North Coast Regional Water Quality Control Board

Subject: Notice of Violation and Transmittal of Inspection Report for March 23, 2021 Inspection of Humboldt County Assessor's Parcel 271-217-002

File: Cannabis Program Inspections, Humboldt County, March 2021,
CIWQS Place ID 844232
Cannabis General Order WDID: 1_12CC419772

Maps and Photolog for Inspection of Humboldt APN 217-271-002 (Prop B) on March 23, 2021. WDID 1_12CC419772, CIWQS Inspection ID 43510635.

Figure 9. Upper graded flat, near GPS Point 447, slash at toe of fill slope.

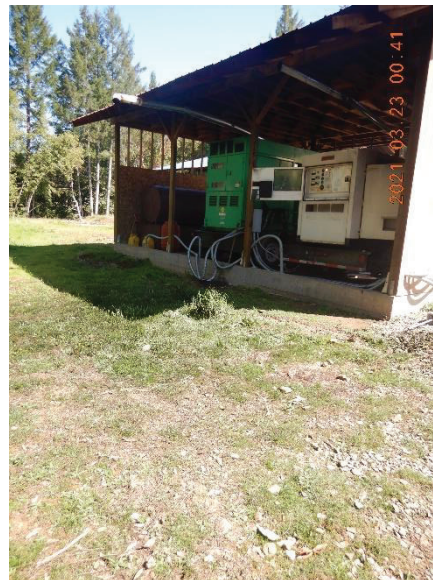
WQ2 - Upper graded flat with runoff from approximately 1 acre, including greenhouse roof catchment and ground surface near generator and fuel storage, is directed to a drain-pipe which discharges to steep hillside, approx. 160 feet above pond.

1. Submit SMP, including all stream crossings, pond at WQ3, and uses at WQ1 in riparian
2. Prior to additional instream work, obtain water quality certification.
3. Improve road drainage and hydrologic disconnections to prevent sediment discharge
4. Consult Water Rights on pond at WQ3 and associated water diversion and use for conformance with Cannabis Policy.
5. Implement measures to ensure that there is no threat of waste discharge from WQ2 to pond & surface waters
